**re:**     **Geotechnical Review of Site Servicing Plans**  
          **Proposed Residential Development**  
          **5618 Hazeldean Road – Abbott's Run – Block 13 – Ottawa, Ontario**

**file:**   PG7640-MEMO.03

## **Site Servicing Plan Review**

FIGURE 1 - RECOMMENDED LATERAL ZONE OF INFLUENCE PROTECTION AREAS

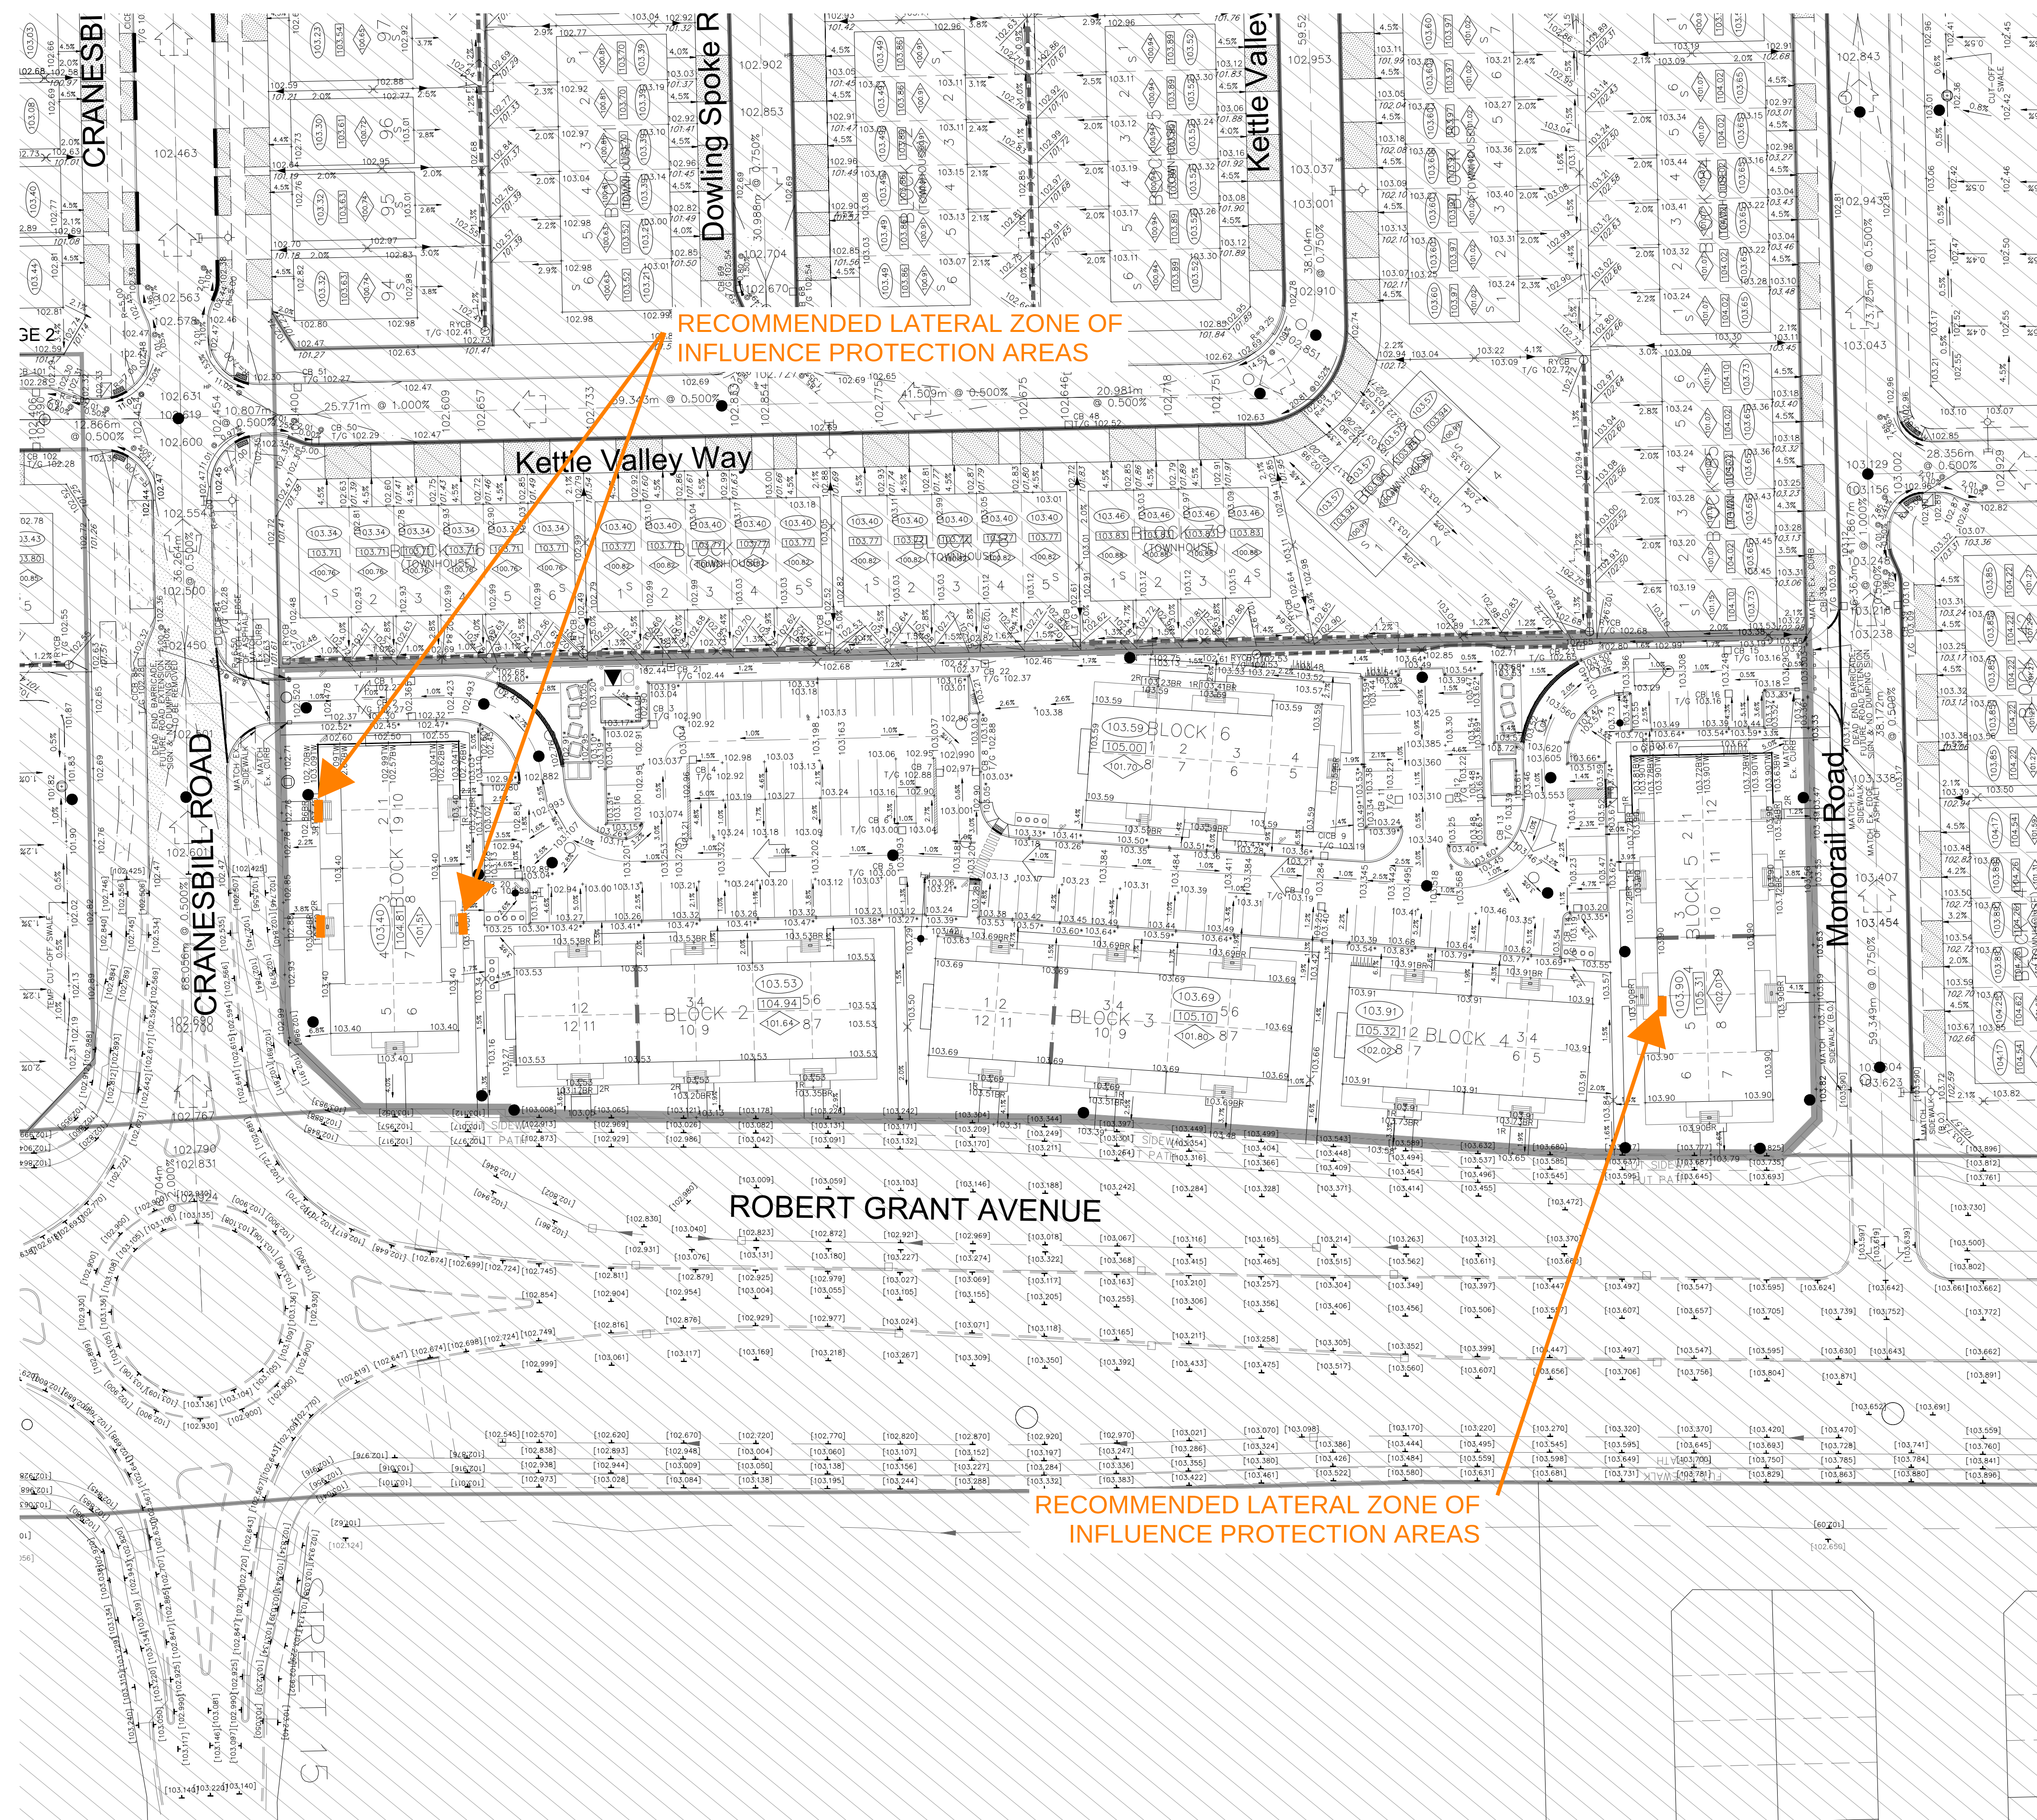
Paterson noted several areas in which underground services are proposed within the lateral zone of influence of the adjacent proposed buildings (i.e. within the plane extending 1 Horizontal:1 Vertical down and outwards from the edge of proposed footing). To ensure that the proposed services do not incur additional loading due to the adjacent proposed dwellings, and to permit future maintenance of the underground services without causing detrimental effects to the adjacent structures, Paterson has provided additional construction recommendations in subsequent sections of the present memorandum

It is recommended that the lateral zones of influence be lowered in the affected areas such that the influence plane (1H:1V) extending down and outwards from the edge of the proposed footings do not contain any underground services. This may be accomplished by extending the underside of footing (USF) for impacted strip footings to the elevations provided in Table 1 below. Alternatively, this may be accomplished by casting a near-vertical lean-concrete (minimum 15 MPa, 28-day strength) in-filled trench extending between the design underside of footing elevation to the recommended elevations provided below in Table 1 to a depth which would be unaffected by service trench works. The near vertical, zero-entry trench should extend horizontally a minimum 150 mm beyond the overlying footing faces.

The extents of the trench running below a strip footing and adjacent to a site service pipe should be terminated by extending the trench upwards and back up to the design underside of footing elevation at an incline of 1H:2V along the opposite oriented-running strip footings. Reference should be made to the attached Figure 1 – Recommended Lateral Zone of Influence Protection Areas for approximate locations in which the above-noted recommendations should be carried out.

| Table 1 – Design Recommendations for Lateral Support Zone Interferences                     |                           |                                                              |                               |
| Block / Lot Number                                                                          | Current USF Elevation (m) | Revised USF/ Underside of Lean-Concrete Trench Elevation (m) | USF Concrete Trench Depth (m) |
| Block 1 – Unit 1 & 2 Staircase Footing                                                      | 101.51*                   | 100.31                                                       | 1.20                          |
| Block 1 – Unit 3 & 4 Staircase Footing                                                      | 101.51*                   | 100.31                                                       | 1.20                          |
| Block 1 – Unit 7 & 8 Staircase Footing                                                      | 101.51*                   | 100.61                                                       | 0.90                          |
| Block 5 – Unit 4 & 5 Staircase Footing                                                      | 102.01*                   | 100.11                                                       | 0.90                          |

The zero entry, near-vertical trench sidewalls are intended to act as the formwork to cast the concrete. The bottom of the excavation should be reviewed by Paterson personnel prior to placing concrete. Once the trench excavation is approved by Paterson, lean concrete can be poured up to the design underside of footing elevation.
